# Sun SPARC® Enterprise M8000/M9000 Servers Product Notes

For XCP Version 1081

Part No. 820-7236-11  
March 2009, Revision A

**FIGURE 6-20** Example of DIMM Information

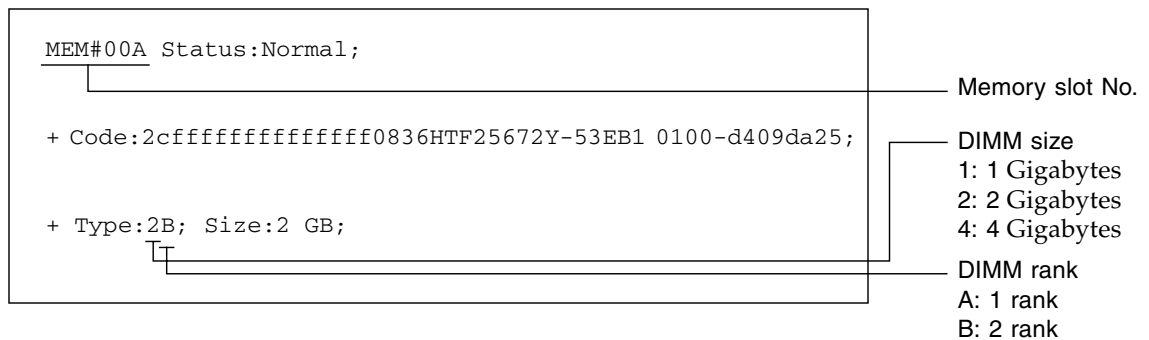
The figure here corrects FIGURE 6-20, “Explanation of DIMM Information,” on page 6-31 in Section 6.4.2.1, “Confirmation of DIMM Information.” The corrected figure is as follows.

FIGURE 6-20 shows an example of how to read the DIMM information displayed in the Type field.

**FIGURE 13-6** Card positioning post and card positioning tab

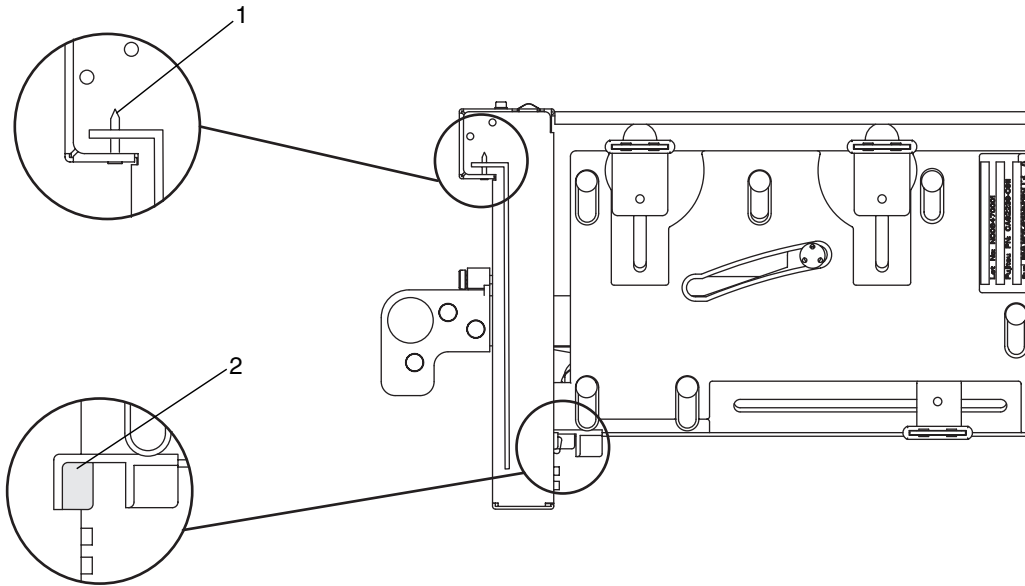
The post (item 1 in FIGURE 13-6) is seated in the notch of the bracket of the PCI card. If the post is not properly seated in the notch, the mounting bracket of the card may be bent and the card may end up being affixed in an inclined position on the PCI cassette. If a card is affixed in an inclined position, it will not be in proper electric contact with the socket on the IOU.

The tab (item 2 in FIGURE 13-6) fits in the notch on the lower part of the PCI card. This tab is helpful in positioning the card when it is mounted on the PCI cassette (however, some types of cards do not have the notch).

**FIGURE 13-8** Sequence of Fixing the PCI Card in Position

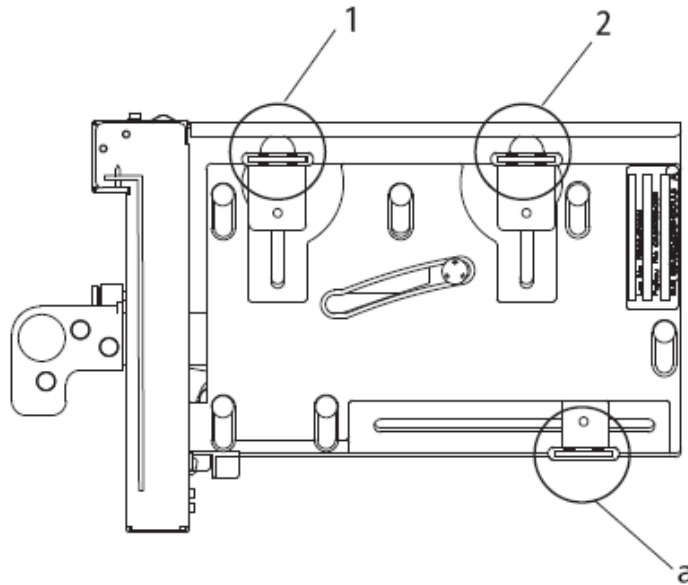
- c. Align the PCI card with the center part of the lower latch of the cassette. Then, while pressing the PCI card against the center part of each of the upper latches of the cassette, tighten the fixing screws in the sequence shown in FIGURE 13- 8 to fix the card in position.

To shift the location of the bottom screw for the PCI card, first secure the card at the lower latch (part a in FIGURE 13-8). Then, tighten the fixing screws in the sequence shown in FIGURE 13-8 to fix the card in position.

**FIGURE 13-9** Latch Positions at the Bottom of the Cassette

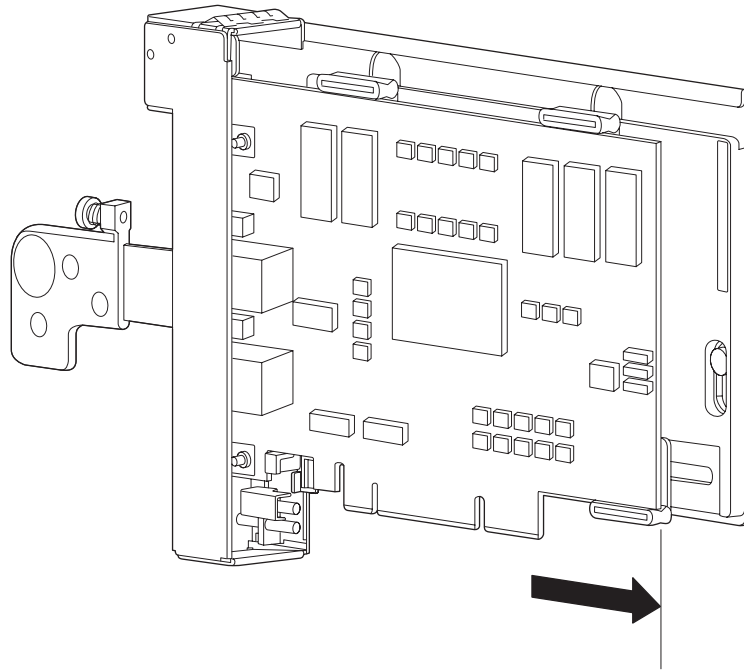
**Note** – To ensure that the PCI card is properly mounted, you need to confirm that the PCI card base is properly centered at the latches and securely fastened in position (FIGURE 13-9 reference).

**Caution** – If the card is short, move the screw at the bottom of the cassette as required. In such cases, place the latches as close as possible to the far end of the card.
